re: Climate Resiliency Review, Mugar Lands

MEMORANDUM

SUBJECT: Resiliency review consultation services related to the East Arlington Mugar site

Figure 9. FEMA FIRMette for Site

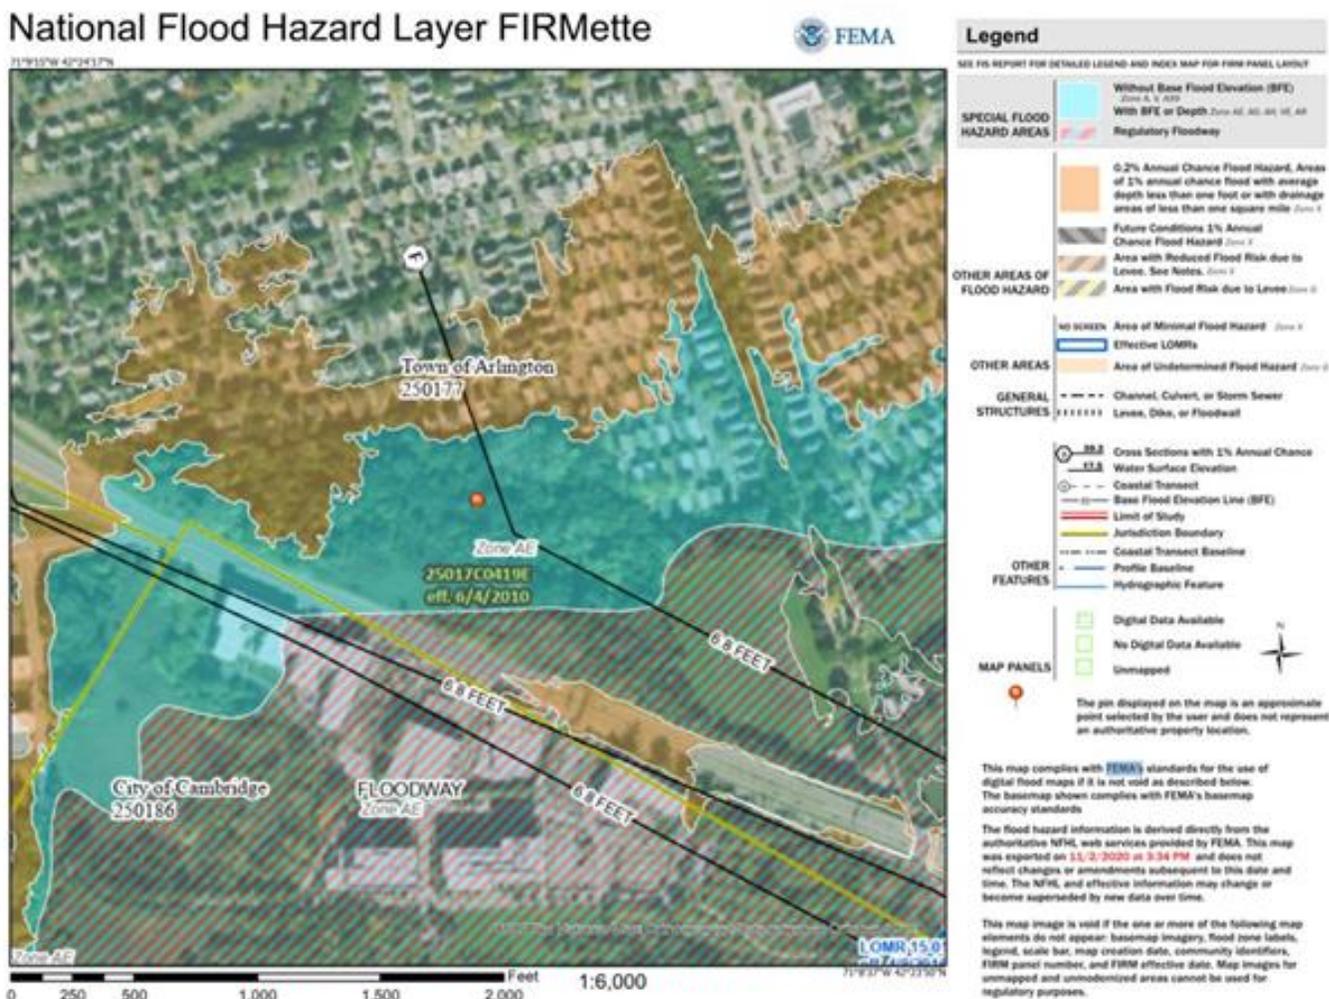
Alewife Brook (Little River)² created by FEMA, the 500-year elevation for the Site is 10.75 feet NAVD88. Furthermore, all of FEMA's elevations for the Site are based on data collected up to June 4, 2010, and do not consider SLR or SS effects due to climate change. The first floor living space for the Thorndike Place development is designed at an elevation of approximately 13 feet-NAVD88, making it suitable for projected SLR and SS effects, but the underground parking area is at a severe risk of flooding.

1. Coordinate to discuss flood elevation findings from Climate Change Vulnerability Assessments conducted by surrounding municipalities and utilize the findings to come up with a DFE that would provide flood protection for the 2070s planning horizon.

Figure 10. Map from the BH-FRM showing the 2070 1% Annual Chance Flood

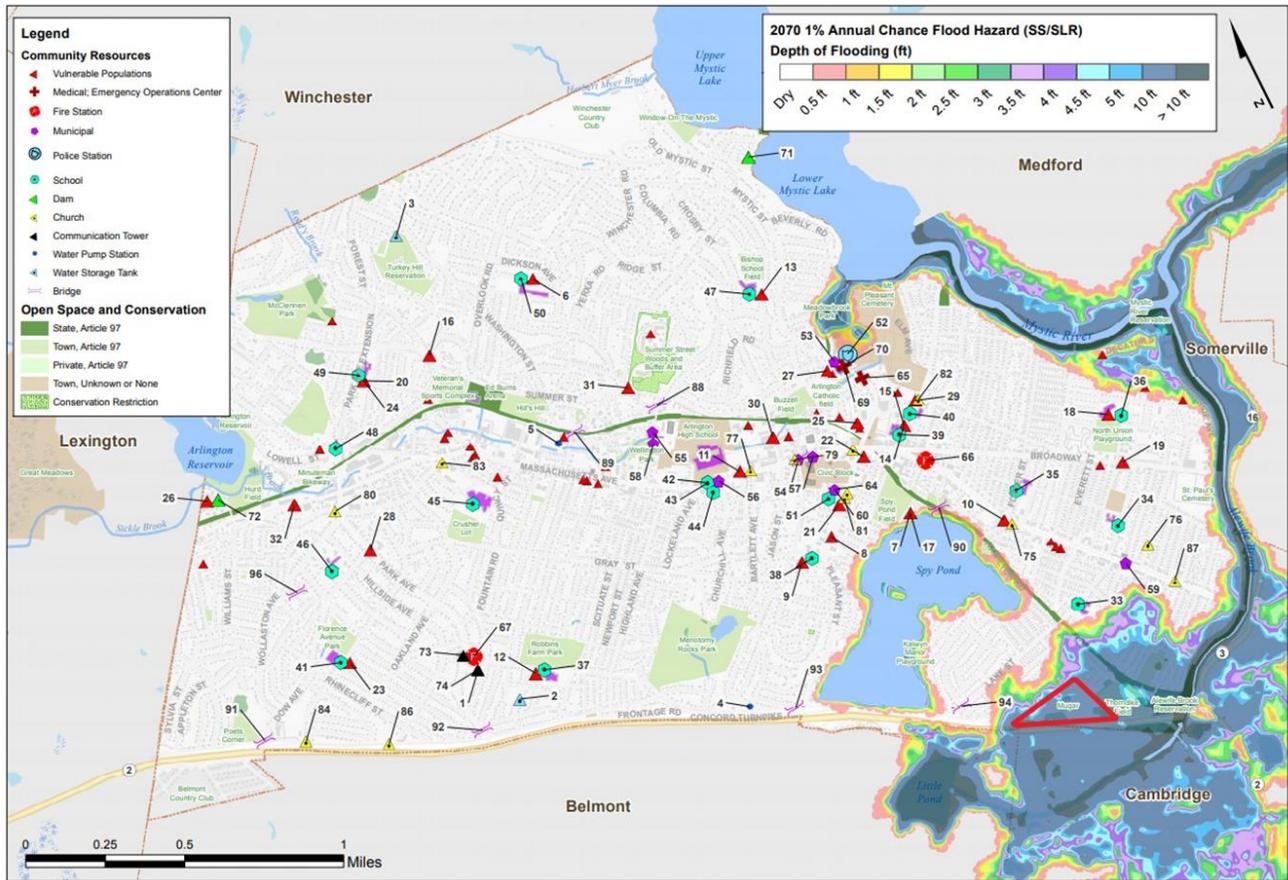
proposed development site, and the site is likely to experience a greater than 20% annual probability of flooding by 2070.³ The Department of Conservation and Recreation (DCR) is actively undertaking a Feasibility Analysis on raising and extending the AED and pursuing this effort in coordination with regional resiliency efforts. The timeline for these improvements is uncertain, which is why the Thorndike Place Development should consider these future flooding impacts. Figure 10 shows a map of the 1% annual chance flood depth projected throughout Arlington for 2070 by the BH-FRM, which was the model used in the Cambridge Climate Change Vulnerability Assessment. This map indicates a projected flood depth of at least 10 feet throughout the Mugar site.

Figure 11. Comparison of Total Storm Depths

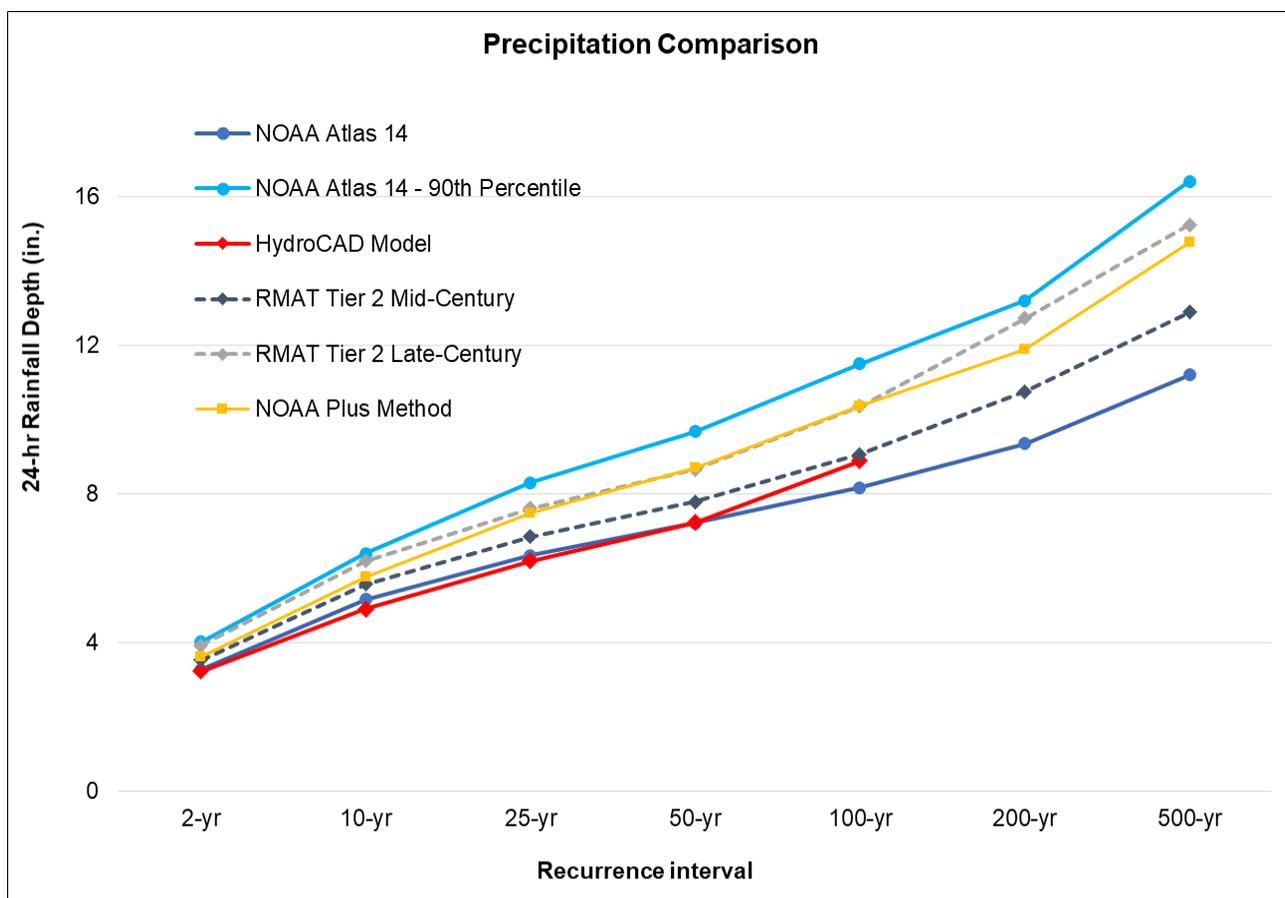
Climate resilient design for the average level of effort (“Tier 2”), as proposed by the RMAT Standards, include percent increases for NOAA Atlas 14 estimates. These percent increases for the mid-century (2030/2050) and late-century (2070/2090) show greater design storm depths than used for the proposed project. A comparative representation of the precipitation depths discussed in this memorandum is shown in Figure 11, with the corresponding values indicated in Table 1, below. It is recommended that these updated precipitation depths be evaluated within the HydroCAD model to appropriately design a stormwater management system at the Site that will be effective in the 2070s planning horizon.

2. Utilize updated 24-hr design storm depths in the HydroCAD model to appropriately design a stormwater management system that will be effective in the 2070s planning horizon. The RMAAT Tier 2 Methodology provides percent increases to the NOAA Atlas 14 design depths used in the current design of the Thorndike development. The efficacy of the proposed stormwater management at the Site should be assessed using the recommended RMAAT Tier 2 Late Century percent increases.

Figure 12. Arlington Land Surface Temperature Map, 2018

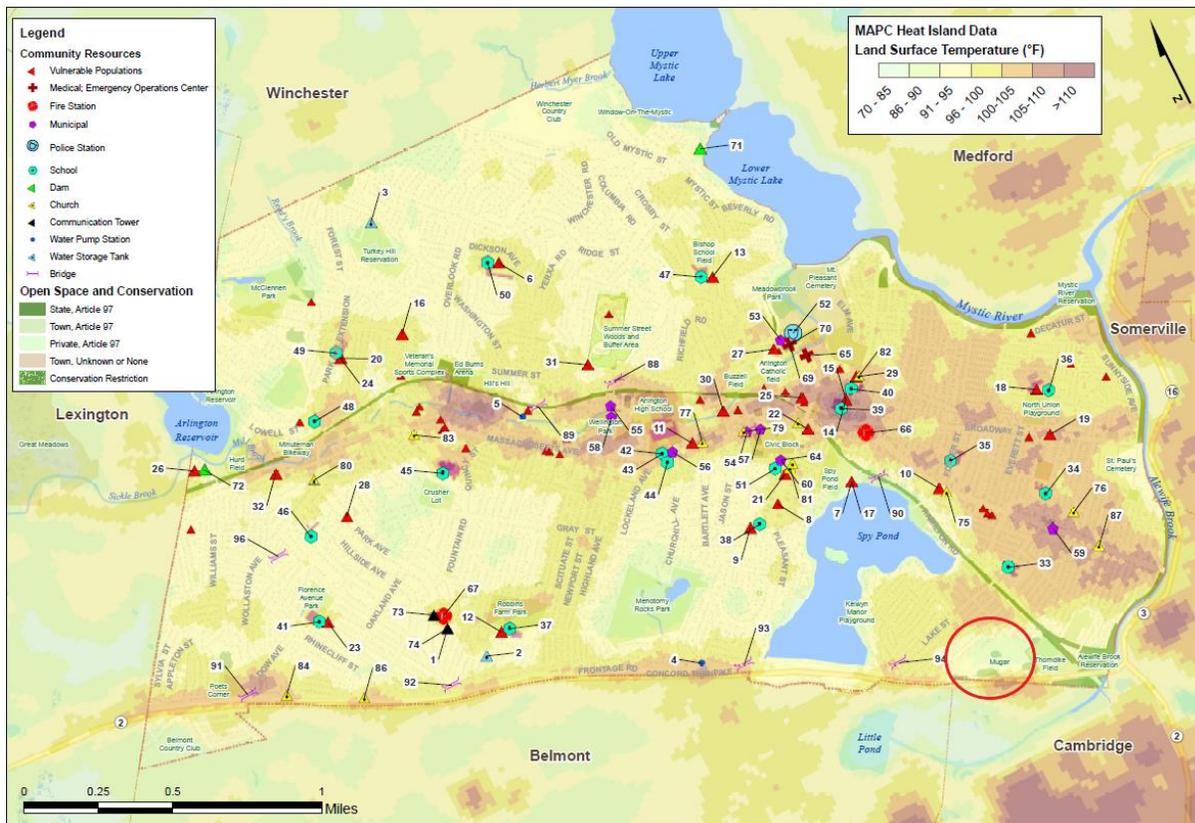
Review of available design documents for the Site does not indicate how development will change land surface temperatures or mitigate the already increasing urban heat island effect. Furthermore, the current Site design does not consider or propose methods to mitigate and protect against future projections for extreme heat.

Taken from the Town of Arlington Community Resilience Building 2018 Report, Figure 12 depicts the current heat island analysis for the Arlington area based on land surface temperature¹⁰. This figure demonstrates that the Site is one of limited areas within the Town that has lower land surface temperatures. The Cambridge CCVA further shows that ambient air temperatures are projected to increase through 2070, becoming dangerous to human health, worsening the situation for already vulnerable populations expected to be living on the Site¹¹.

5. Provide information on how development of the Site will change land surface temperatures to prevent exacerbating the already increasing urban heat island effect.
